RE: **ADDITIONAL INFORMATION.**

**Planning Application for development to a permitted storage warehouse building (Previous Planning Reg. No. SD15A/0254), located at M50 Business Park beside the M50 Ballymount Interchange, Ballymount, Dublin 12. D12 HW6X. The development will consist of;**

**Planning Ref. No: SD21A/0214**

Example of weather protected secure cycle parking (short term or long term).

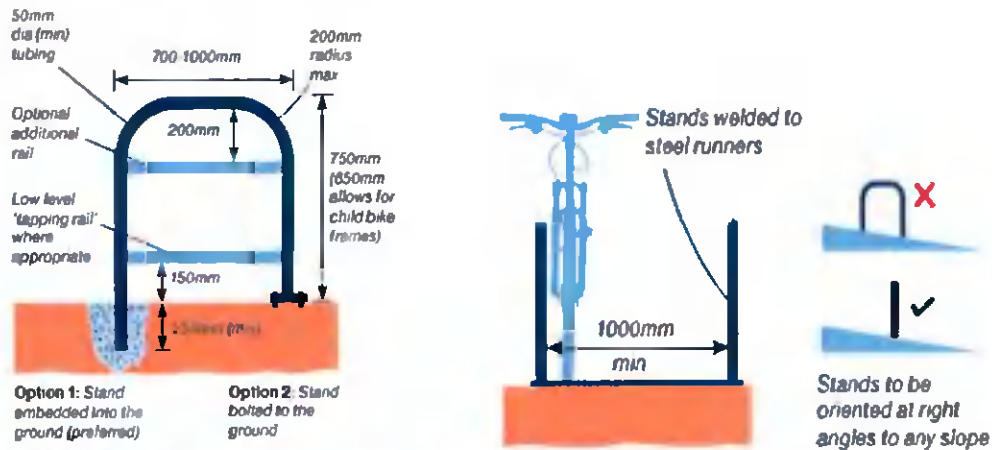
**Item 6**

The applicant recognizes the promotion of cycling as a travel opportunity and is part of the drive to promote alternatives to the private car and encourage more sustainable means of travel. One step in this process is to improve the provision, safety, convenience and general environment for cycling by ensuring that the needs of cyclists are fully taken into account as part of this development. It is proposed that the amount of good quality cycle parking needs to be increased. The applicant proposes to provide adequately secure, weather protected parking for visitor parking as follows;

The location of additional 10 no. bicycle parking bays have been included on our revised Site Layout Plan and Ground Floor Plan drawings.
